DEVELOPMENT REVIEW COMMITTEE (DRC) COMMENT REPORT

PROJECT NAME: MedMen - Sunrise

CASE NUMBER: PLN-SITE-19100008

REQUEST: Site Plan Level III Review: Conditional Use for Medical Cannabis Dispensing Facility

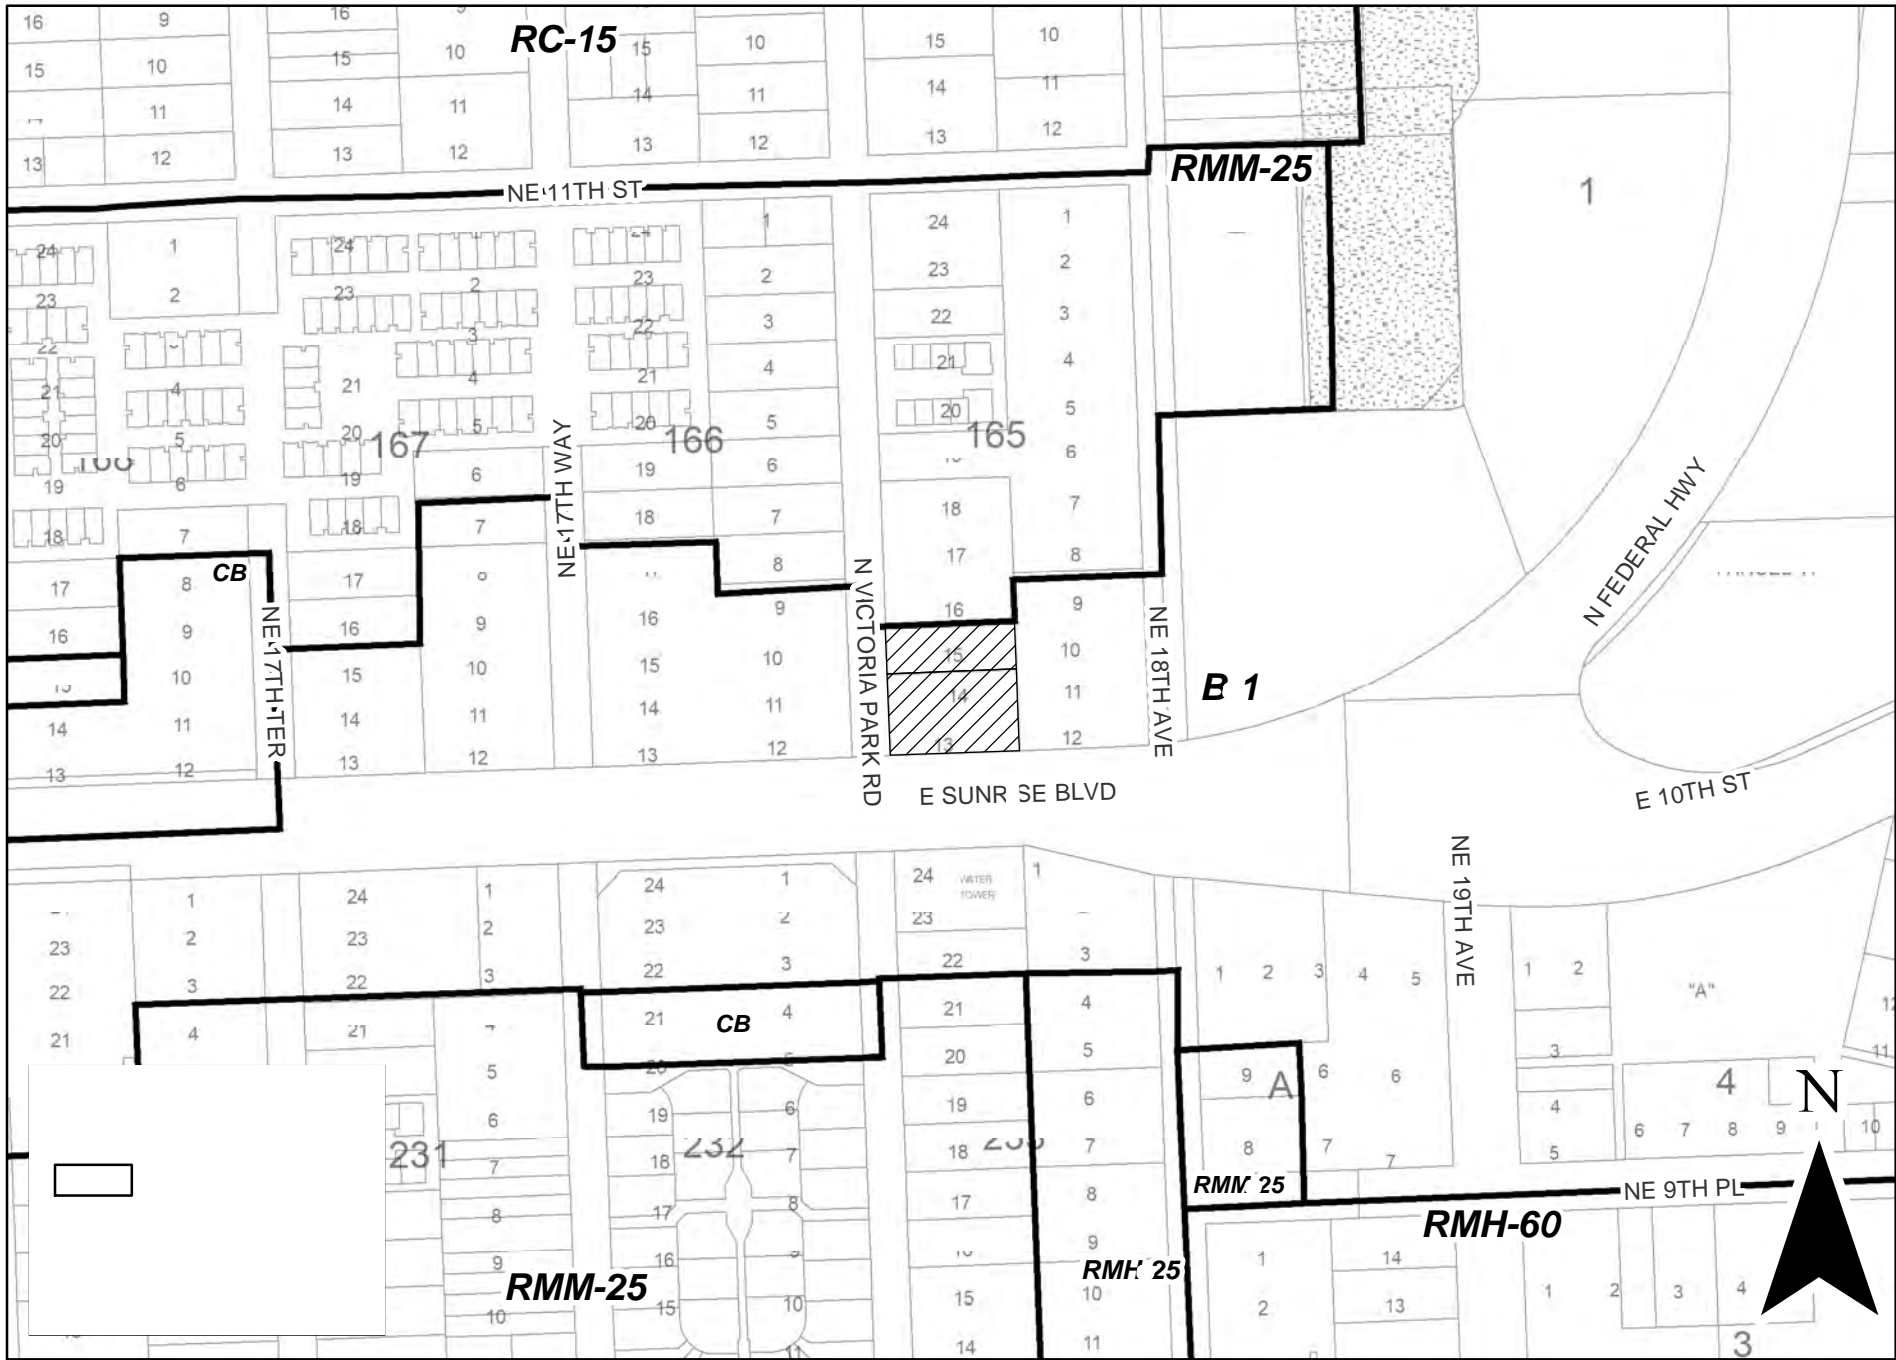
10. The parking spaces on the southwest corner requires a vehicular use area (VUA) buffer of 10-feet due to the abutting right-of-way (ROW), pursuant to Section 47-21.12.A.1. To alleviate providing a 10-foot VUA, consider shifting the building to the southwest corner of the site and moving the parking spaces to the southeast corner with the front façade being placed in front of the Florida Department of Transportation (FDOT) corner chord. Moving the parking spaces to the southeast corner of the site would only require providing a VUA buffer of 2.5 feet abutting the easterly property.

11. Coordinate and discuss the Security Plan with the Police Representative and ensure that the application addresses criteria as defined in ULDR, Section 47-18.46.D.3, Medical Cannabis Dispensing Facility.
